SERVICE BULLETIN

PRODUCT JH-110 RECORDERBULLETIN NO. 202**SERVICE BULLETIN**DATE APRIL 29, 1976P.C. BD. POWER HARNESS No. _____ECO NO. 162 IN NEW PRODUCTION April 20, 1976

PRODUCT JH-110 RECORDER

P.C. BD. REPRODUCE BD.No. PC27C16ECO No. 79IN NEW PRODUCTION March 17, 1976

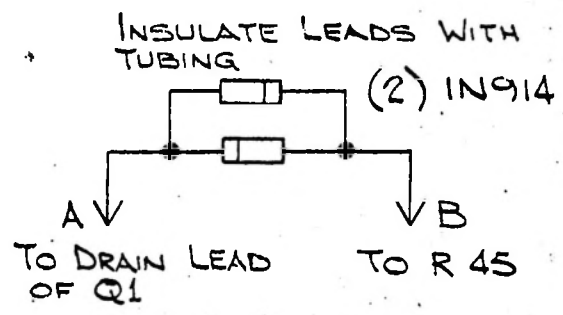
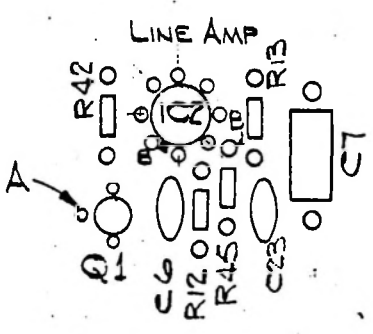
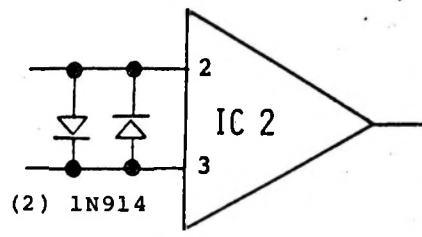
Add two (2) 1N914 diodes from pin #2 to pin #3 of the output op-amp (IC2). Repeat for each Reproduce Bd. (Reverse parallel connection)

To protect the op-amp from static High Voltage failure.

FIG 4

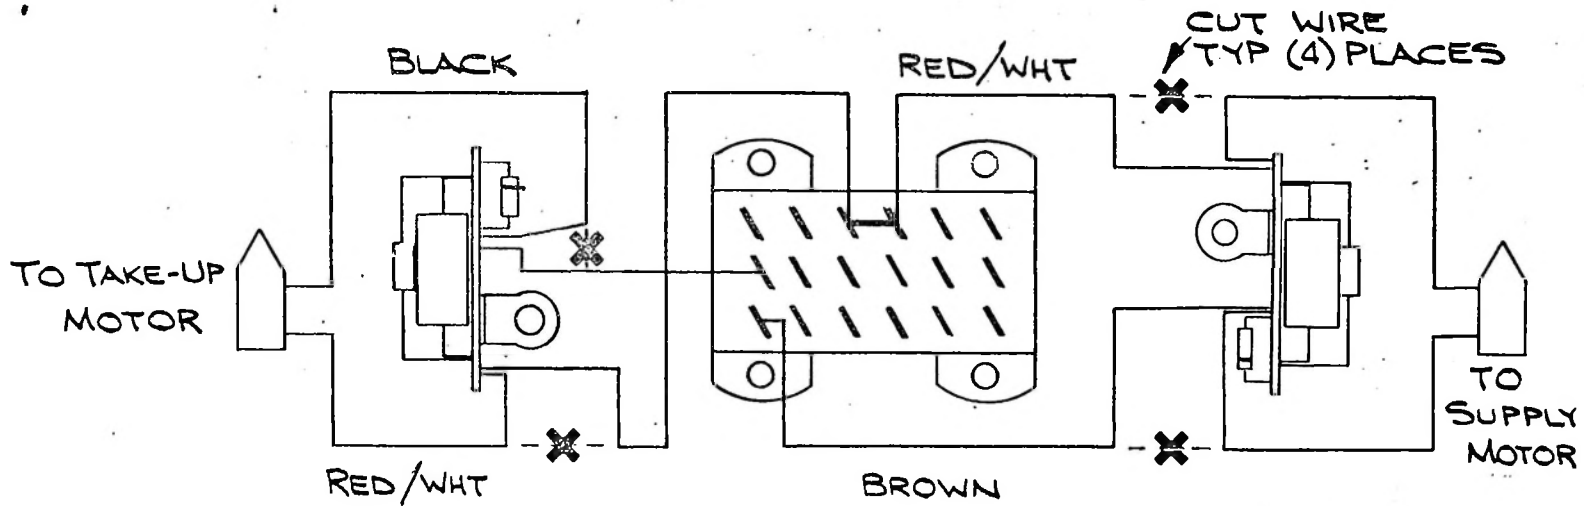
1. Remove Power Cable from Power Supply and Transport. Open MALE END. Clip out the component assemblies. (There are two assemblies similar to Fig. 1 on the reverse side of this page.) Reassemble the plug.
2. Drill two holes in the Deck Electronics Chassis - one on each side of the Power Plug. (See Fig. 2 for the correct positions) Holes should have clearance for a 4-40 screw.
3. Mount the two sub-assemblies (Fig. 3) with the large components turned AWAY FROM the power plug. (See Fig. 4)
4. Unplug the connector to the Supply motor. Cut both wires and reconnect as shown in Fig. 4. Replace the Supply motor connector.
5. Unplug the connector to the Take-up motor. Cut both wires and reconnect as shown in Fig. 4. Replace the Take-up motor connector.

DRILL TWO HOLES .128 DIA.
(CLEARANCE FOR 4-40 SCREW)

P.C. BOARD JH-110 Power Supply No. PC26D27

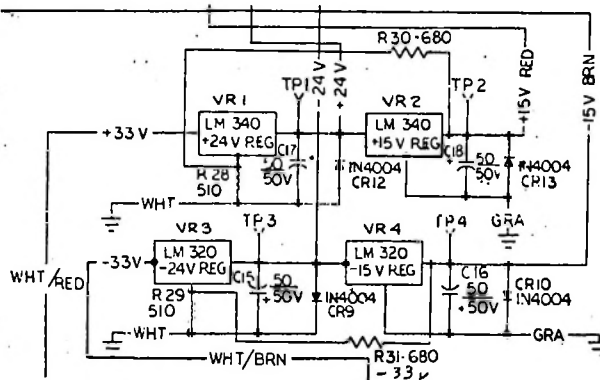
1. Remove CR8 and CR11 (In5238)
2. Add a 680 ohm $\frac{1}{2}$ watt resistor from the output leg of VR2 to the reference leg of VR1.
Add a 680 ohm $\frac{1}{2}$ watt resistor from the output leg of VR4 to the reference leg of VR3.
Add a 510 ohm $\frac{1}{2}$ watt resistor from the reference leg of VR1 to ground.
Add a 510 ohm $\frac{1}{2}$ watt resistor from the reference leg of VR3 to ground.

To improve reliability of the 24v regulator circuit.
To stop destruction of 24v regulators in short circuit mode.

(d) Head Housing Connector PC2600-0605-00

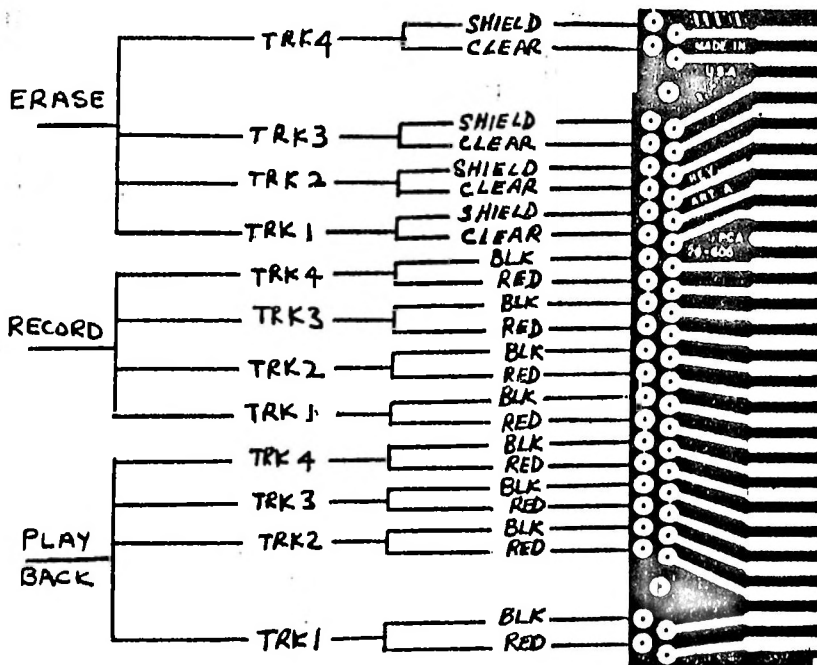
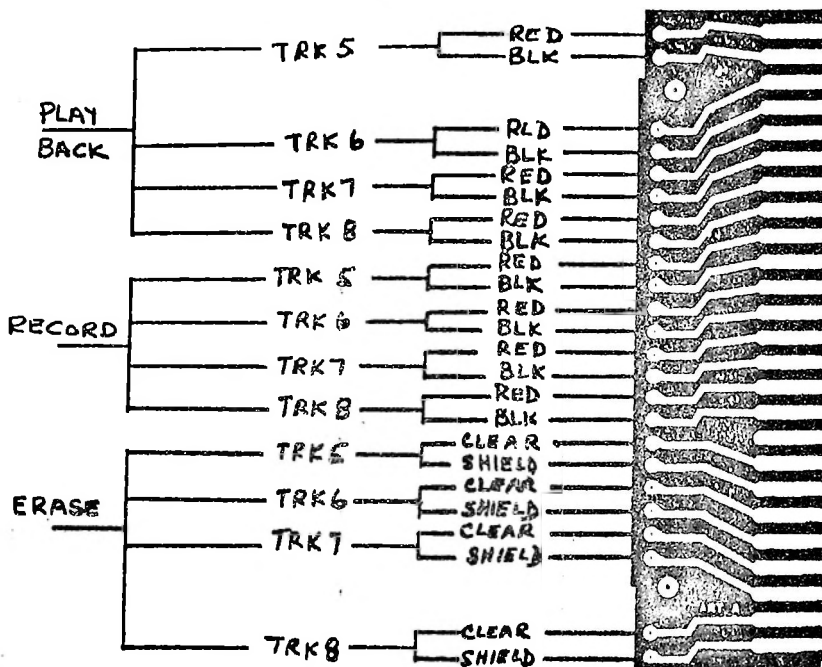
Rewire as shown Pg 3 of 3.

SS 2700C0914 - 00B
 RECORD BD
 STD & BDCST

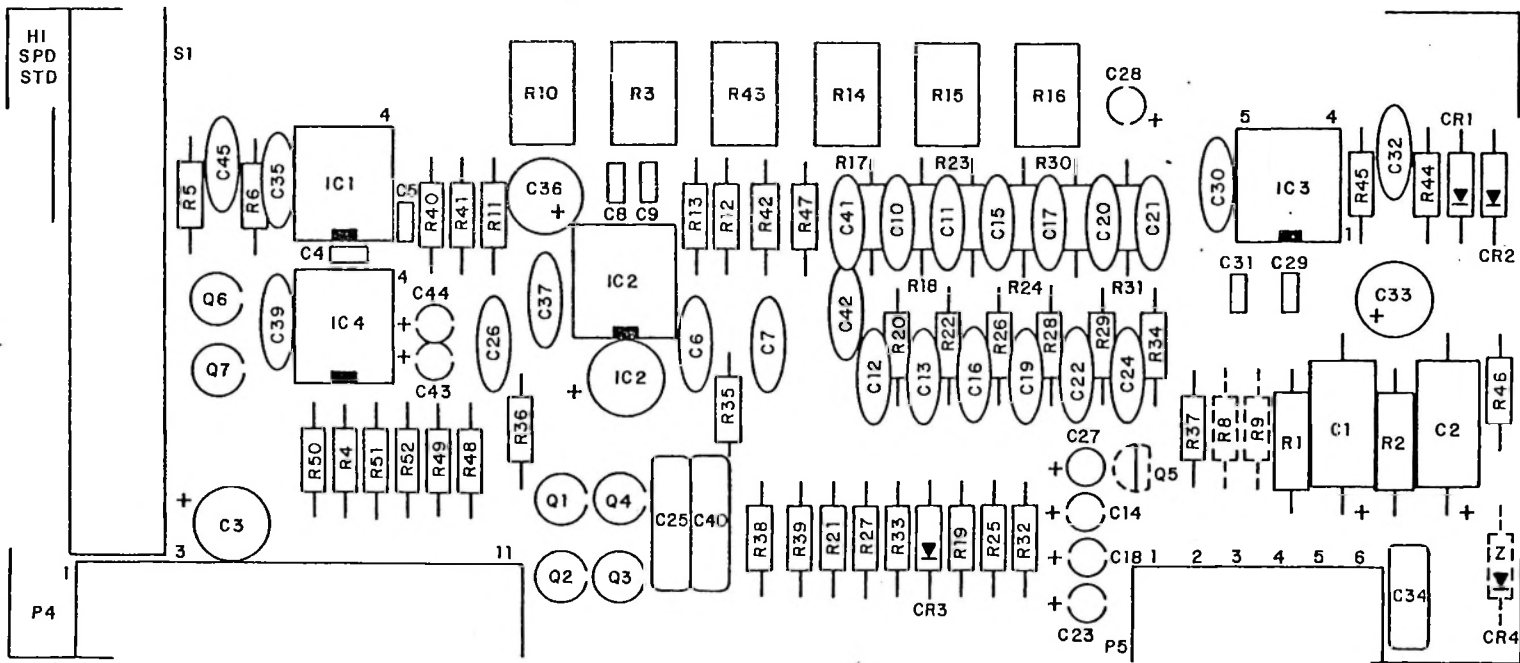
Re-installation of Linearity Control on Record Bd. useful on certain tape formulations.

- Step 1) Remove Jumper between R43-CW and R43-S
- Step 2) Remove Jumper at CR1
- Step 3) Install a 2K ohm 18T Side Adj. Pot at R43
- Step 4) Install 2- 1N34A Diodes at CR1 and CR2
- Step 5) Delete label on card pull handle and replace with new label.

PC2700C0916-00B
 SILKSCREEN
 I/O CARD, JH110A

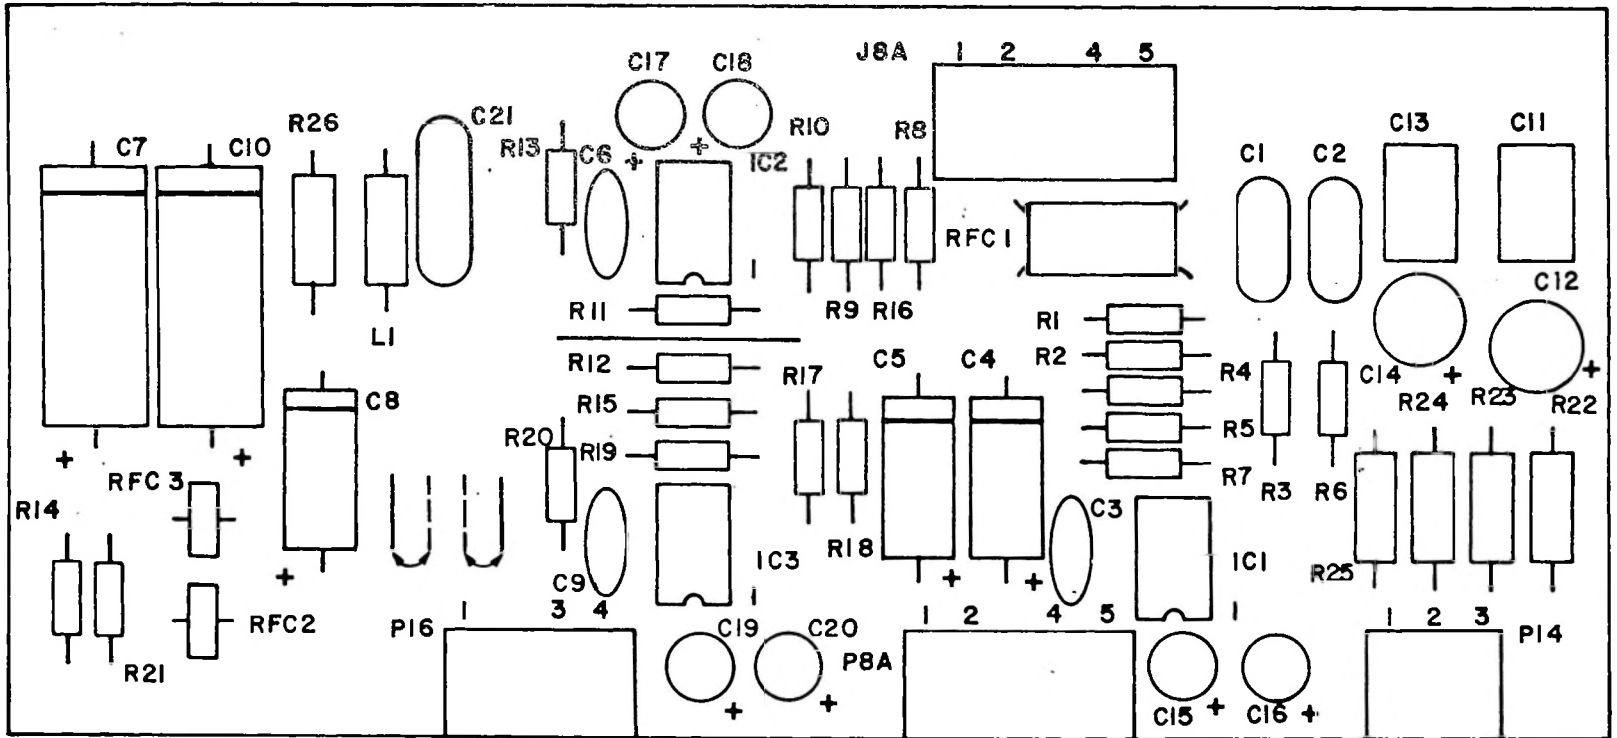
To correct phase error in I/O Amp Board that will be present in all modes.

Change jumpers on I/O Board as shown on reverse side.

SS2700G0913-00J
 SILKSCREEN
 REPRO BD, JH-110A
 BDCST & STD

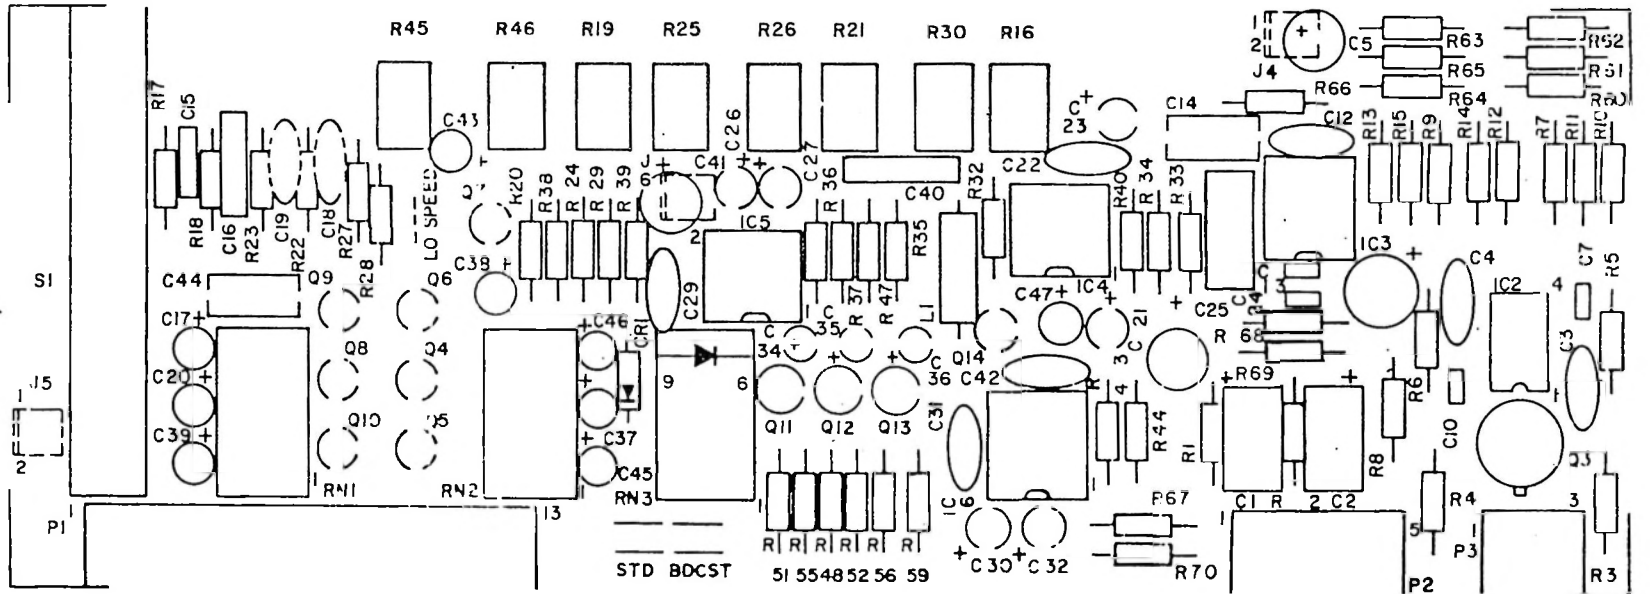
To correct monitor punch-in noise.

Add a 1N914 diode to RN3 from Pin 9 to Pin 6 as shown on drawing on reverse side.

P.C. BD. Repro Board NO. PCA2700-913

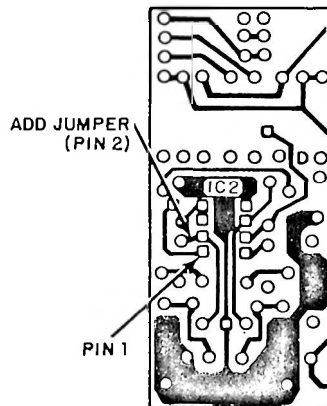
Missing land on art work. This land is a connection for the HF compensation cap. This could cause possible oscillation of the Input Amplifier. (IC2)

Add wire between pad and pin 2 of IC 2 as shown on illustration below.

Figure 1

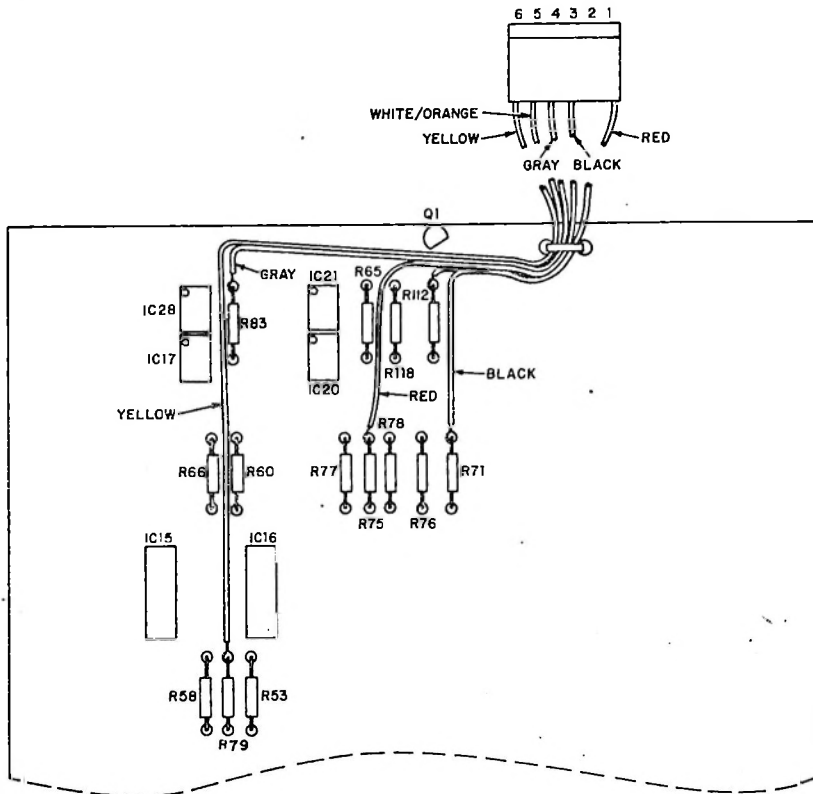
- STEP 1. Modify the Analog Torque Board, PCA2600-001.
 - a. Remove the Analog Torque Board from the transport.
 - b. Solder the wires of the harness to the resistor leads as shown in figure 1.

Figure 2

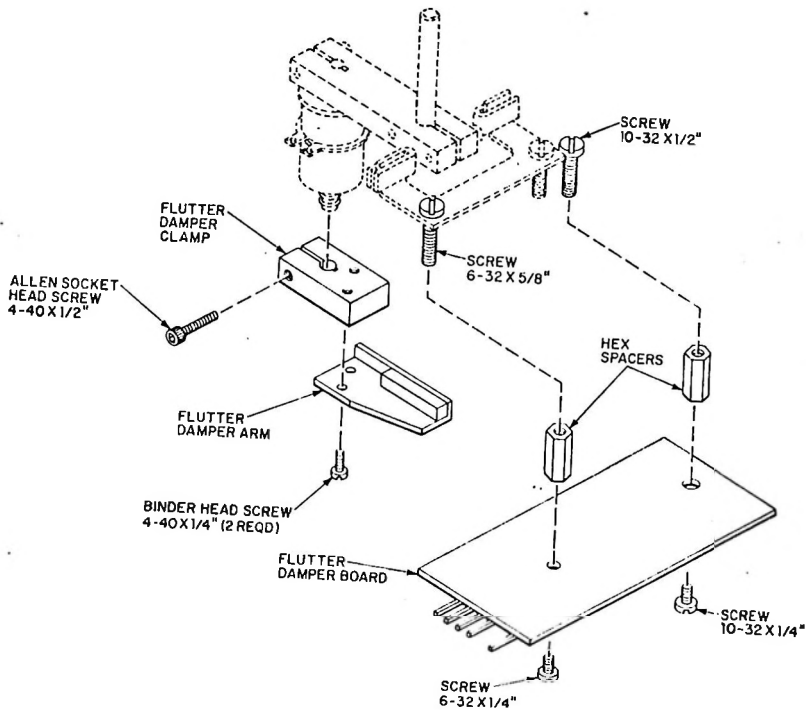
- a. Replace the screw just removed in step 4c with the longer 6-32 screw supplied and tighten the 6-32 hex spacer to it.
- b. Tighten the screw formerly holding the dashpot bracket and tighten the 10-32 hex spacer onto it.
- c. Mount the circuit board on the spacers as shown in figure 2 using the two screws supplied.

Figure 3

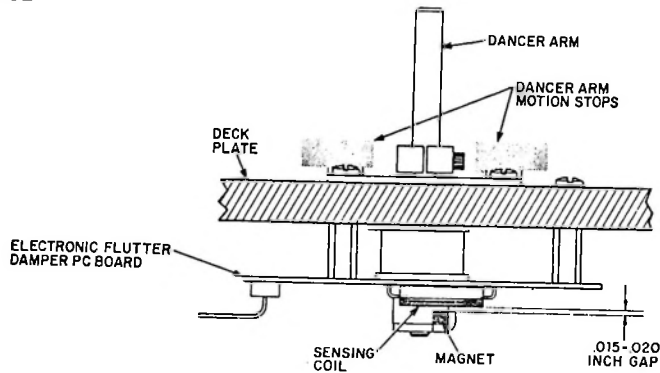
- c. Refer to figure 3. Center the dancer arm between its motion limit stops. Insure that the magnet is centered over the sensor coil with a .015 to .020 inch gap between the coil and the magnet. Tighten the retaining screw.
- d. Recheck the alignment. Move the dancer arm from one stop to the other. The magnet's motion should be centered over the coil. Adjust if necessary.

PROCEDURE FOR MODIFYING THE SPEED CONTROL HARNESS TO USE THE
NEW (25C600) PHASE LOCKED LOOP BOARD.

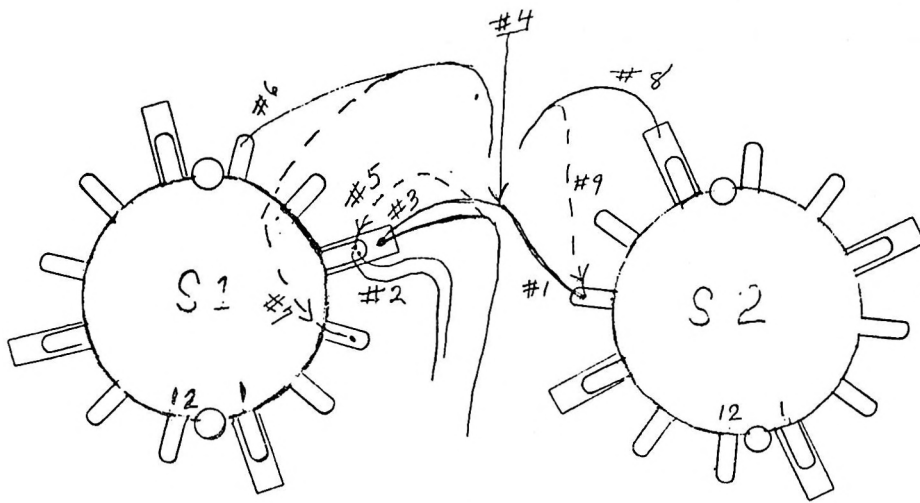
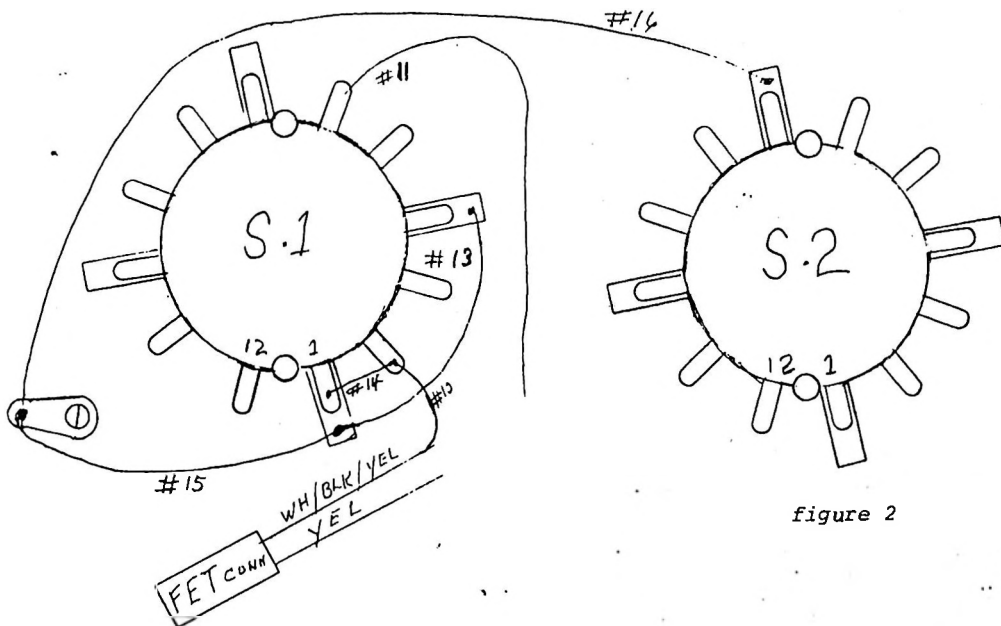
- # 1 Disconnect the WHT/BLK/ORN wire from Pos 9 (S2).
- # 2 Disconnect BOTH WHT/BLK/YEL wires from Pos 4 (S1).
- # 3 Disconnect BOTH WHT/BLK/ORN wires from the wiper behind Pos 4 (S1).

- # 4 Discard the short wire which originally connected Pos 9 (S2) and the wiper behind Pos 4 (S1).
- # 5 Reconnect the remaining WHT/BLK/ORN wire to Pos 4 (S1).

- # 6 Disconnect the YEL wire from Pos 6 (S1).
- # 7 Reconnect the YEL wire to Pos 3 (S1).
- # 8 Disconnect the WHT/BLK/GRN wire from the wiper behind Pos 7 (S2).

- # 9 Reconnect the WHT/BLK/GRN wire to Pos 9 (S2).
- #10 Locate the WHT/BLK/YEL wire which goes to the FET connector. Reconnect the free end of this wire to Pos 2 (S1).

- #11 Reconnect the remaining WHT/BLK/YEL wire to Pos 6 (S1).
- #12 Install a ground lug under the screw just to the left of S1.
- #13 Install a jumper wire between the wiper behind Pos 1 (S1) and the wiper behind Pos 4 (S1).

- #14 Install a jumper wire from Pos 1 (S1) to Pos 2 (S1).
- #15 Install a ground wire from Pos 1 (S1) to the ground lug.
- #16 Install a ground wire from the wiper behind Pos 7 (S2) to the ground lug.

26B160

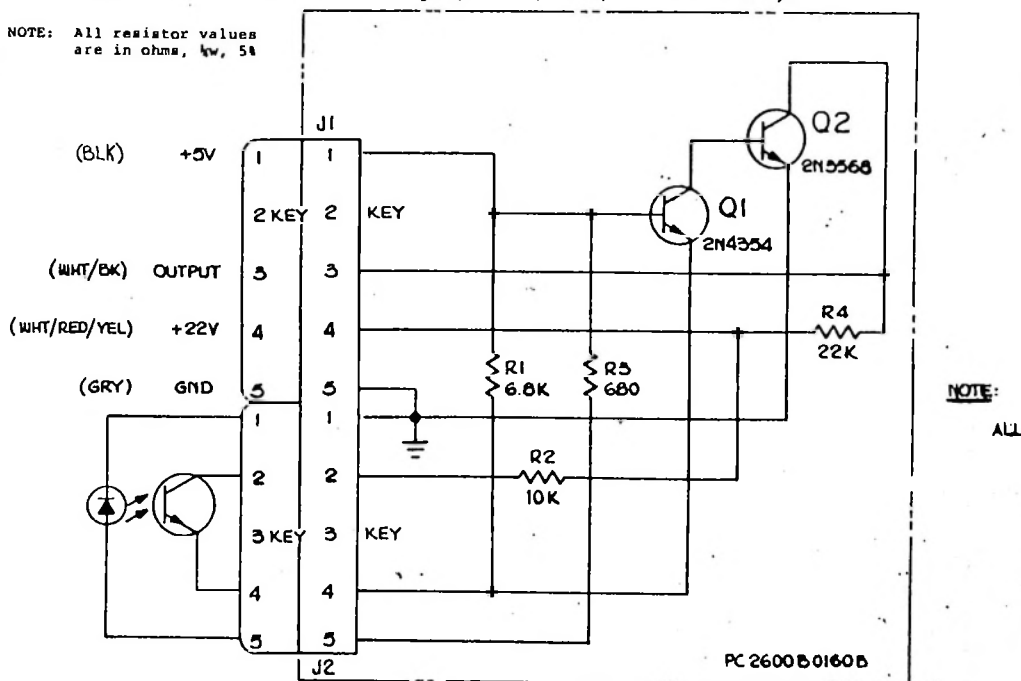
1. Unsolder all of the wires going to this terminal strip. Remove the terminal strip. Mount the amplifier board, using the same mounting screw.
2. IF there were TWO BROWN wires going to one of the lugs on the terminal strip, solder these two wires together and insulate the end with tape (*These wires are not to be connected to the new board*).
3. Refer to the drawing below and the Wiring Chart on the back of this page for the correct color code for your machine.

NOTE: R19 on deck Mother Board must be replaced with a Jumper wire to provide +5v.

P.C. Bd. Phase Locked Loop Board No. 25C600AECO No. 394 IN NEW PRODUCTION ON November 18, 1976

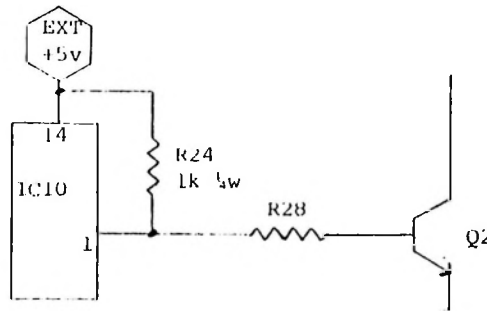
To improve the performance of the capstan speed output signal.

1k $\frac{1}{2}$ w resistor between pin 1 and pin 14 of IC10. (add on circuit side of board)

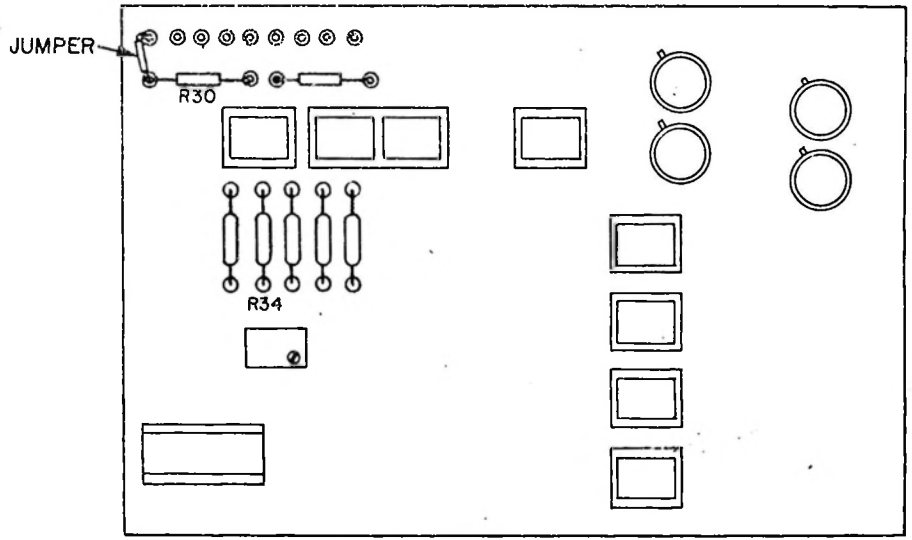
P.C. Board land is missing, thus when having the MVC (Manual Velocity Control) sensitivity set to high and activating one of the transport controls (i.e. fast wind mode, torque limit, or Autolocate command) this may cause the transport to latch in MVC mode.

- Step 1) Add jumper wire (20 or 22ga) on to the component side of the P.C. Board between Molex P21-1 and R30. (See diagram on reverse side).
- Step 2) Change R34 from 100 ohm $\frac{1}{2}$ w resistor to 1.5K ohm $\frac{1}{2}$ w resistor to limit maximum MVC sensitivity.
